Subject: [FIXED] Beam pipe valves?

1) [viewer.gif](#), downloaded 698 times

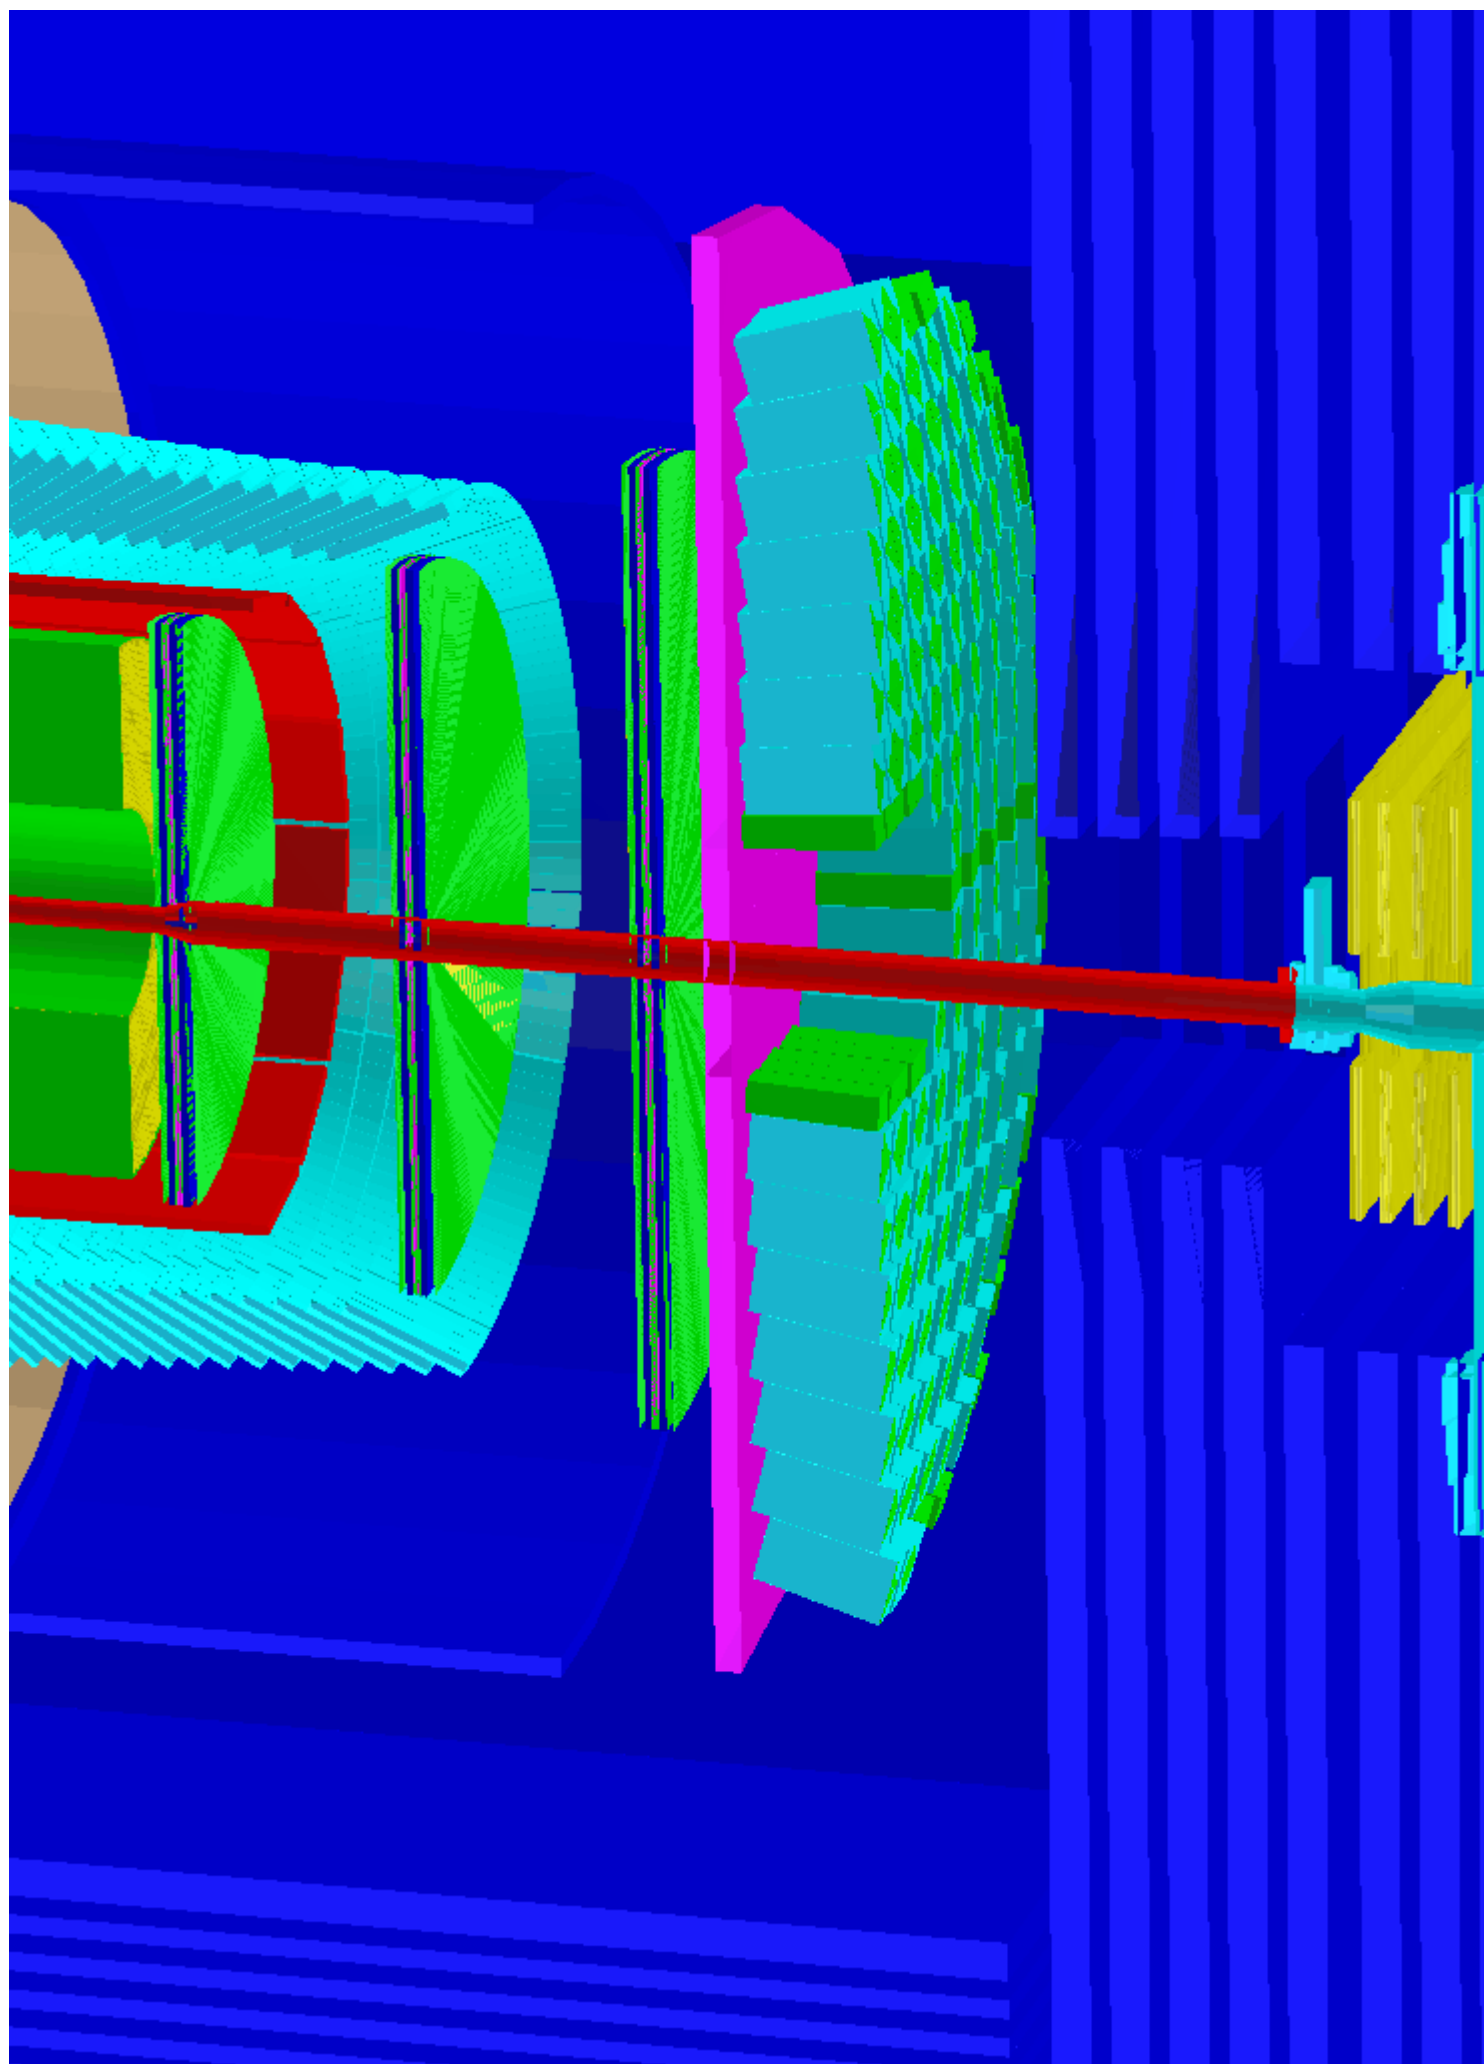
Dear all,
today I plotted the PANDA geometry and I have seen something strange:

In the OGL drawing you can see that the pipe has a sort of "tower" which is in the middle of the muon filter. I am wondering what is wrong there, if the "tower" should be really there, if maybe the muon filter should be modified to host it, or if maybe we have some geometry problems.

Indeed, this is the first pumping station downstream of the target. The description corresponds to what is to be found on EDMS since several years. So I guess that muon description is not up to date?

Fixed!
